## ADDENDUM No. 2

**Date:** May 12, 2026 **Project No:** M25011  
**Project Name:** Request for Proposal: Town of Shelburne, Pine Grove Avenue Upgrades and Urbanization  
**To:** All Bidders

DRAWING TITLE: PROPOSED GRADING PLAN SHEET 1

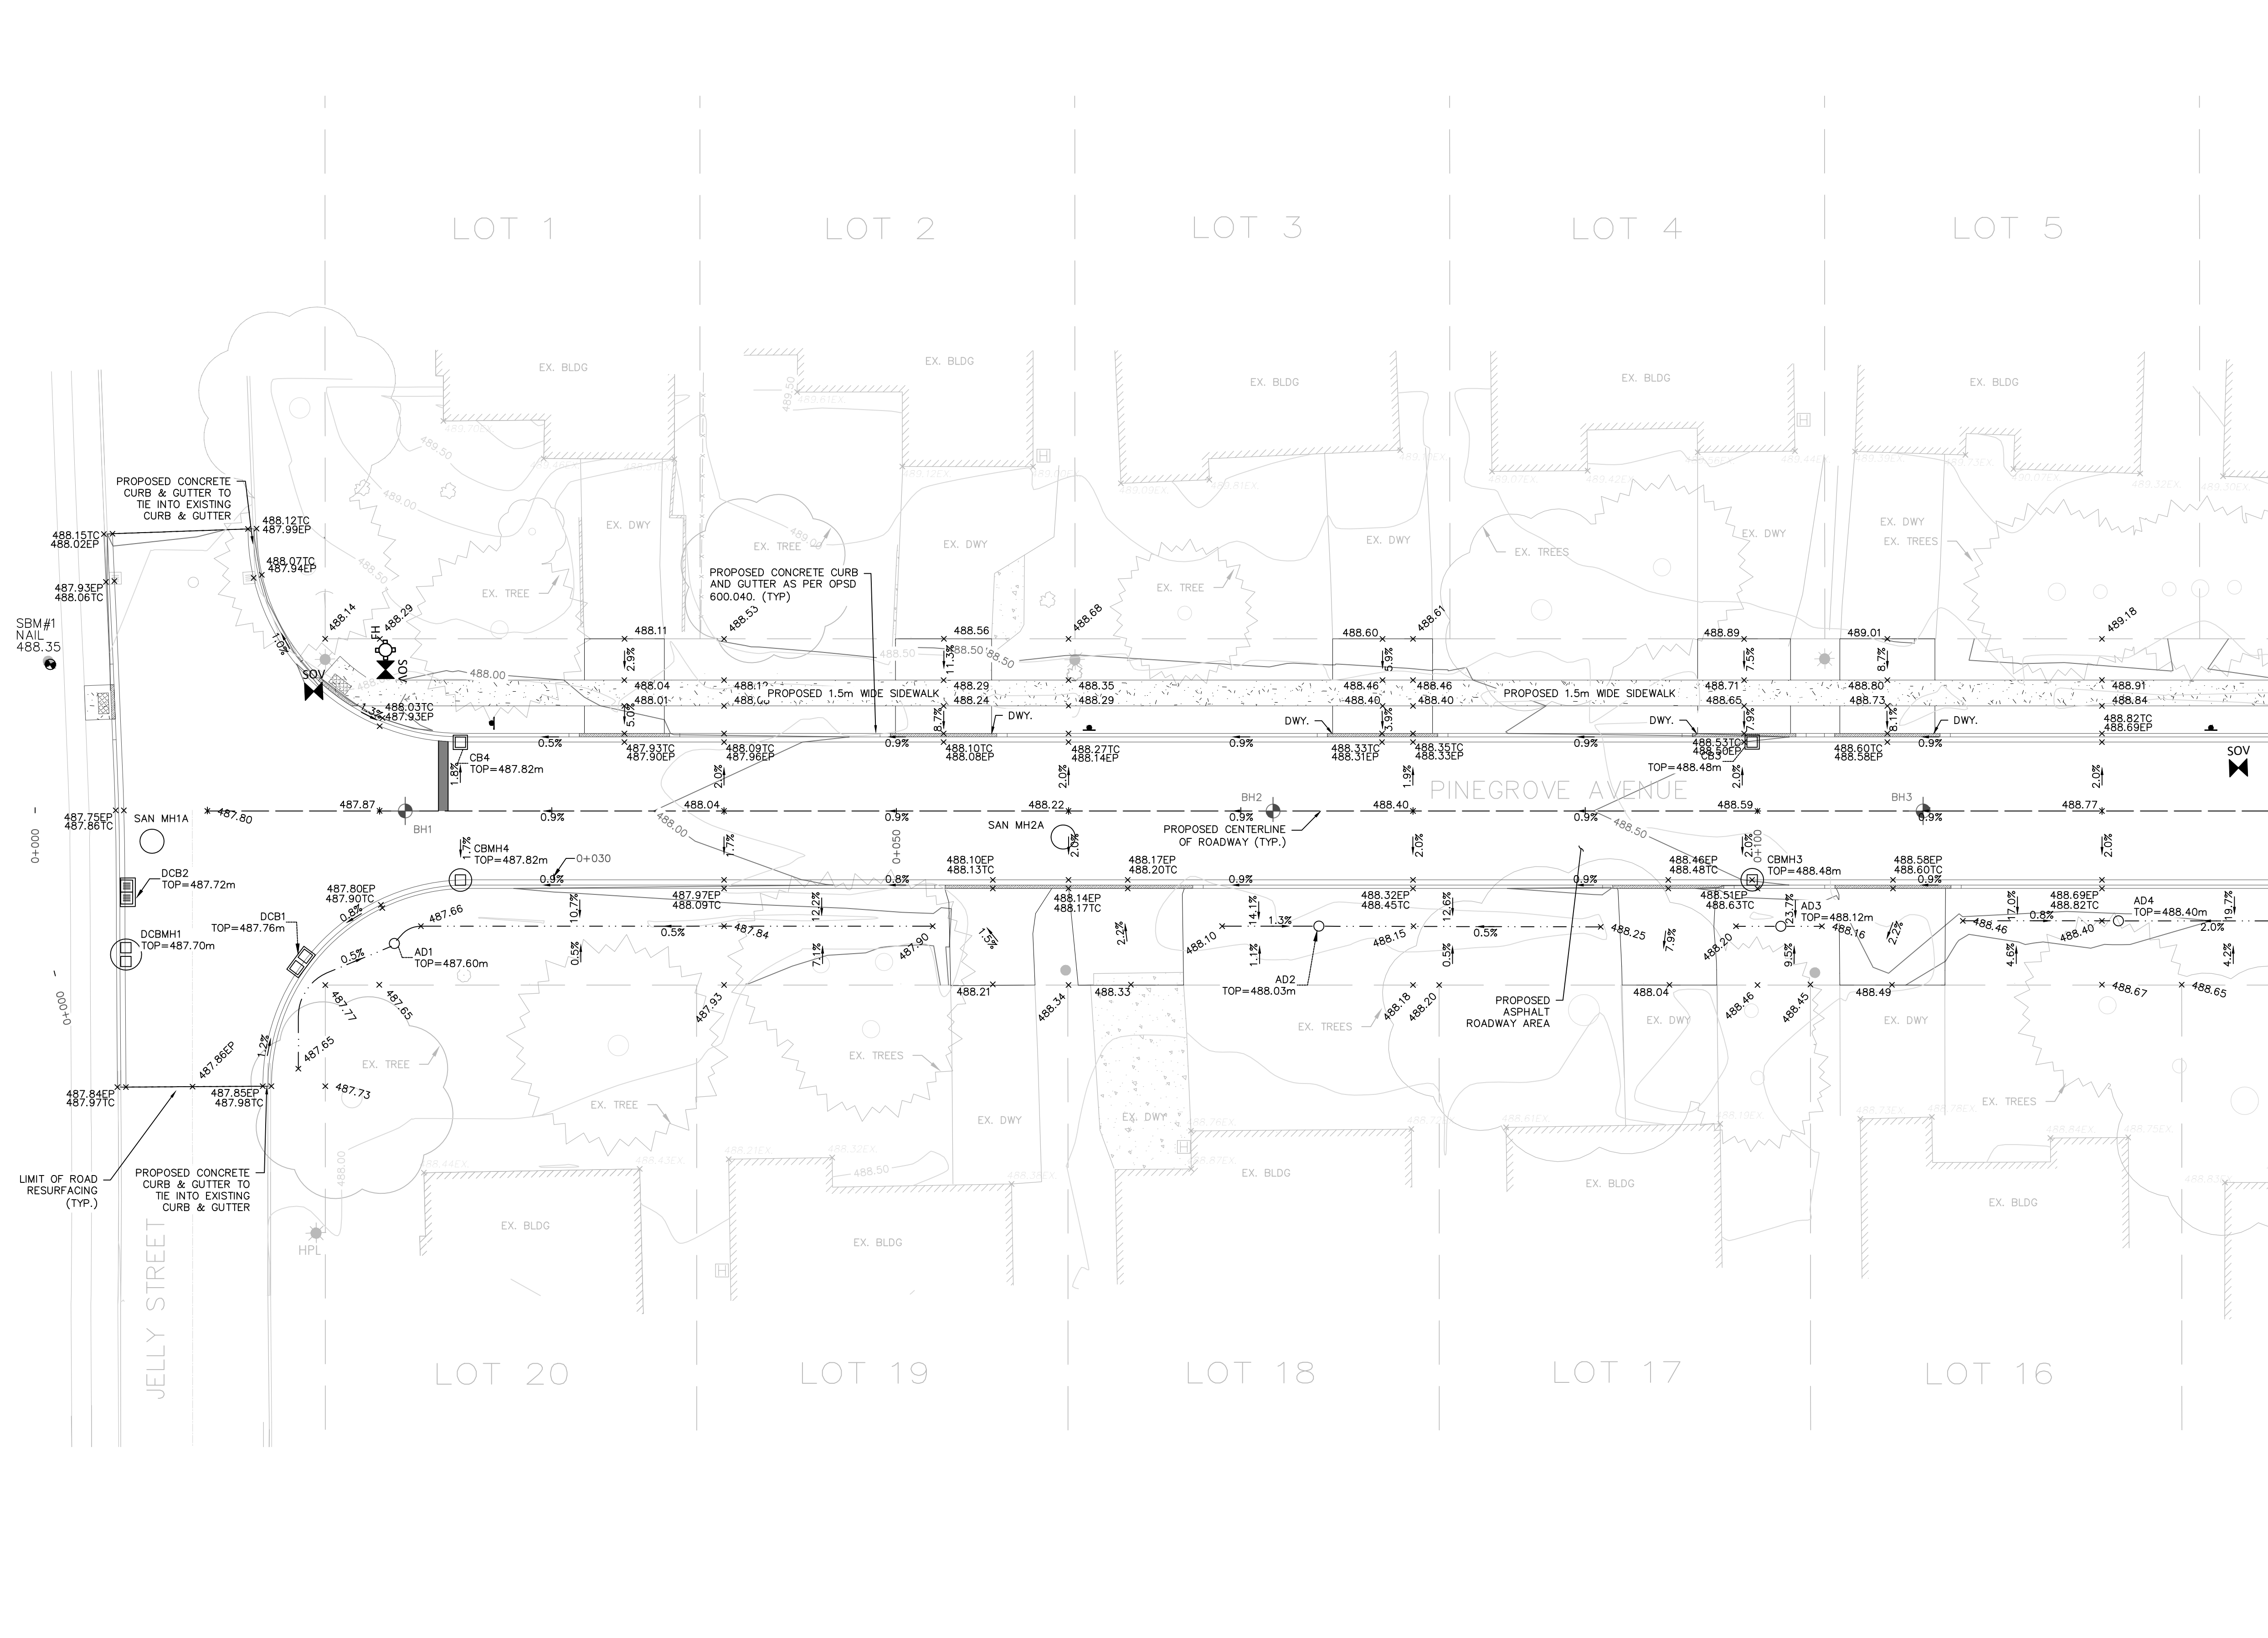
2. Bidders shall REMOVE page 32, Schedule C of the Schedule of Unit Prices, and REPLACE with the attached. (1 page)
3. Bidders shall REMOVE AND REPLACE the following Contract Drawings with the attached: (2 pages)
  - Drawing C2.3: PROPOSED GRADING PLAN SHEET 1
  - Drawing C2.4: PROPOSED GRADING PLAN SHEET 2

The drawings include the revisions listed below. Corresponding changes on other drawing sheets not issued in this addendum will be reflected in the Issued for Construction drawing set.

- a. Revised proposed finished grade elevations within ROW.
  - b. Revised road section design for station 185 to 227 to be superelevated design, with station 160 to 185 being transition area between crowned road and superelevated road.

- c. Revised structure lids elevations to accommodate revised grades.
  - d. Revised curb and gutter & sidewalk ramp linework to more accurately reflect proposed specification.

- e. Minor alignment revision to CB and CBMH structures alignments to proposed gutter lines.
  - f. Deleted CB1 structure.
  - g. Deleted 7.6m 300mm diameter storm lead from CB1 to CBMH1.

- h. Revised AD structures shapes to be more accurate to proposed specification.
  - i. Slight revision to all AD structure alignments and surrounding grading.

- j. Revised AD1 structure location.
  - k. Revised AD1 structure lead connection. It is now connected to DCB1 structure via a 5.52m of 300mm DIA. PVC SDR 35 storm sewer. It was connected directly to the 450mm DIA. PVC storm sewer via 5.63m of 300mm DIA. PVC SDR 35 storm sewer lead.
